Submission to NSW Independent Planning Commission (IPC) re Valley of the Winds Wind Farm (SSD-10461)

Figure 1-DPHI bushfire mitigation measure

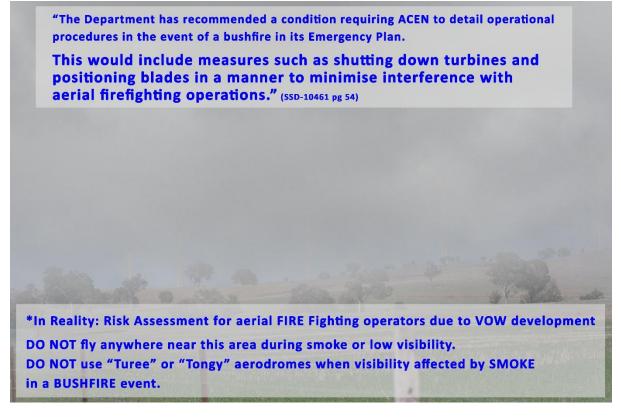
Figures 1 and 2 show that measures recommended by DPHI are potentially life threatening as they do not address the core issue – that the presence of hundreds of

giant turbine blades will prevent safe access by aerial fire fighters regardless of the position of the blades, the turbines being turned off or lit.
